Borough of Hatfield

PLANNING COMMISSION

A. Howard Heckler Subdivision Plan Update

PLAN OF SUBDIVISION
 PREPARED FOR
HOWARD E. HECKLER
 LAND SURVEYOR
 BOROUGH OF HATFIELD, MONTGOMERY CO., PA.

DATE PREPARED
 DATE REVISION
 DRAWN BY
 CHECKED BY
 SCALE
 1"=20'
 PLAN SHEET NO.
 1 of 2

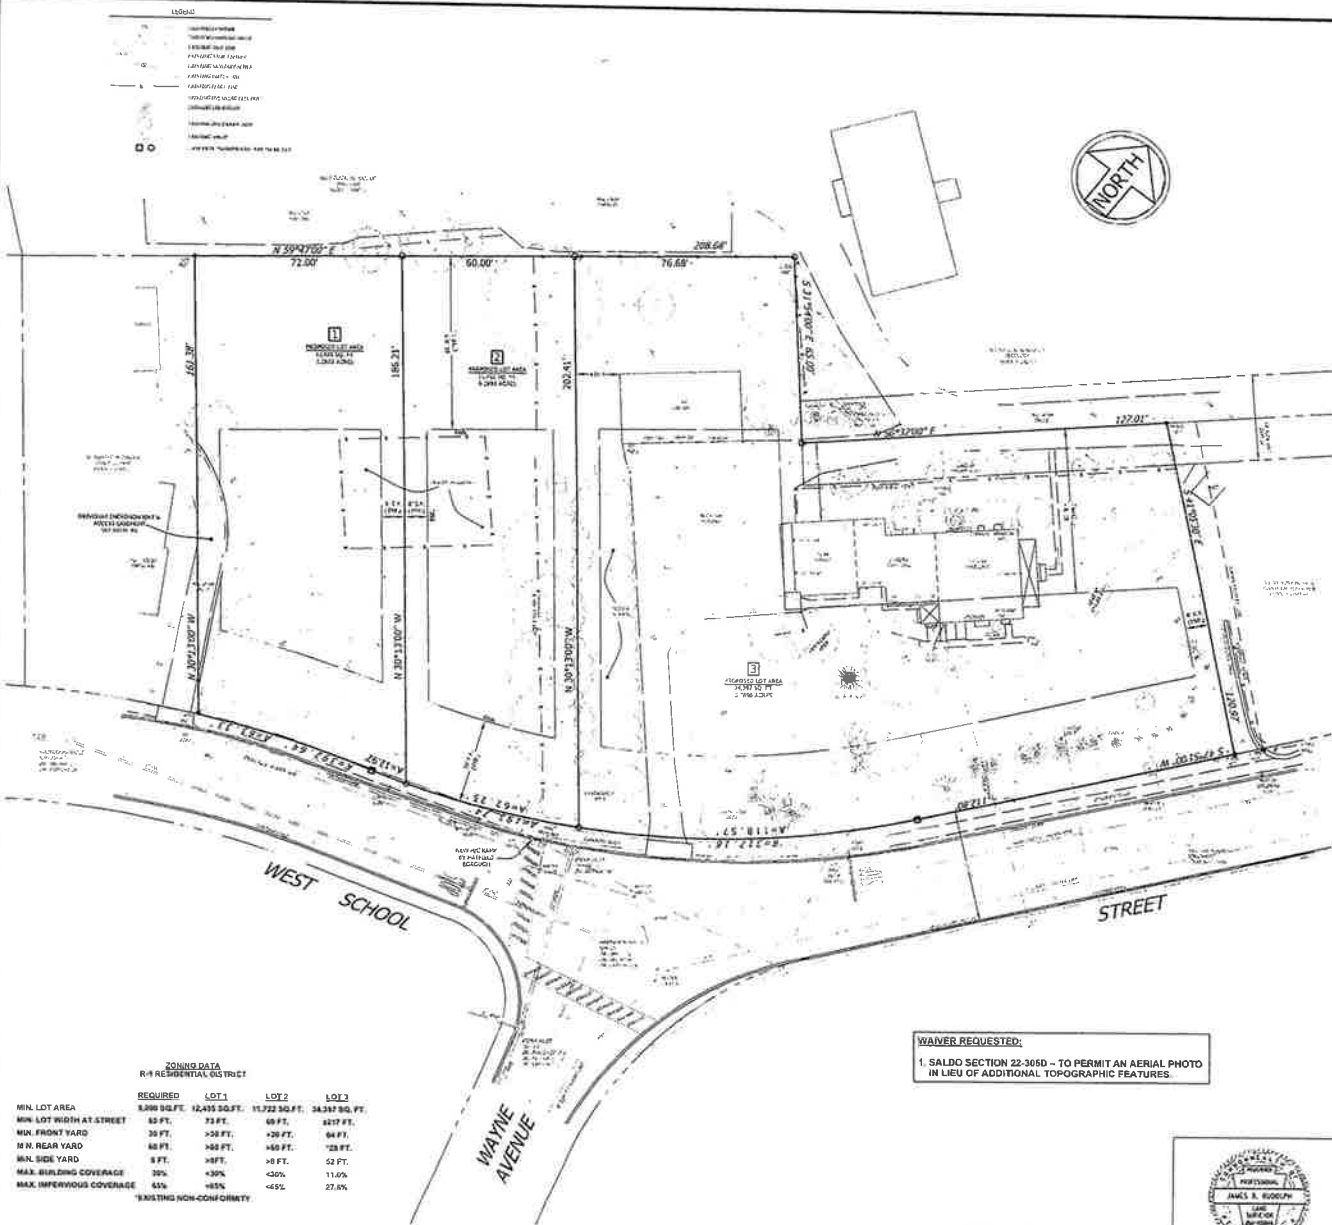
The following waiver request was noted on sheet 1 of 2 of the submitted plan:

1. §22-305.C.(7) – The total tract acreage shall be added to the plan.
2. §22-305.C.(15) – The property boundary line and new lot line types shall be added to the plan legend.

3. §22-305.D.(1)(d) and (e) – The cartway width and surface conditions for existing streets bordering the tract shall be labeled on the plan.
4. §22-305.D.(7) – Soils types and information shall be shown on the plans.

5. §22-305.D.(9) – The existing buildings on the tract shall be labeled as “To Remain” or “To Be Removed” as applicable. A label shall be added describing the type of any buildings and structures located within 100 feet beyond the tract boundaries.

6. §22-307.B.(2)(f) – Note #12 on Sheet 1 shall be expanded to include the concrete monuments to be set. The size and material of all monuments and pins shall be indicated.

7. §22-420.B. – Street trees are required at a spacing of no more than 50 feet along the subdivision. One additional tree would be required to be planted approximately at the common lot line of Lots 1 and 2. Note 11 on sheet 1 of 2 requests future improvements to be the responsibility of the developers of those individual lots as part of the required future permits.

The plan should clarify which lot will be responsible for the required street tree.

1. Metes and bounds information shall be provided for the existing Driveway Encroachment & Access Easement shown on Lot #1.
2. The plan shall identify if the existing fenced-in garden that will be located on both Lots 1 & 2 will remain or be removed.
3. The label referring to the “New H/C Ramp by Hatfield Borough” shall be deleted.
4. Legal descriptions shall be submitted for the three lots created by the subdivision. The Lot 1 legal description shall include a reference to the existing driveway encroachment.
5. Note 15 on sheet 1 shall note that public sewer will be provided by Hatfield Borough and the Hatfield Township Municipal Authority.
6. All signature blocks and certifications shall be signed, and notarized as appropriate, as part of the final plan approval and recording process.

1. Shown on Sheet 1.
2. Shown on Sheet 1.
3. Shown on Sheet 1.
4. Shown on Sheet 1.
5. Site buildings labeled on Sheet 1. Off-site buildings labeled on Sheet 2.
6. Shown on Sheet 1.
7. Shown on Sheet 1.

1. Shown on Sheet 1.
2. Shown on Sheet 1.
3. Deleted from Sheet 1.
4. Descriptions will be submitted prior to final approval.
5. Shown on Sheet 1.
6. Signatures and certifications will be added prior to recording.
7. No response required.
8. These reviews are in process.
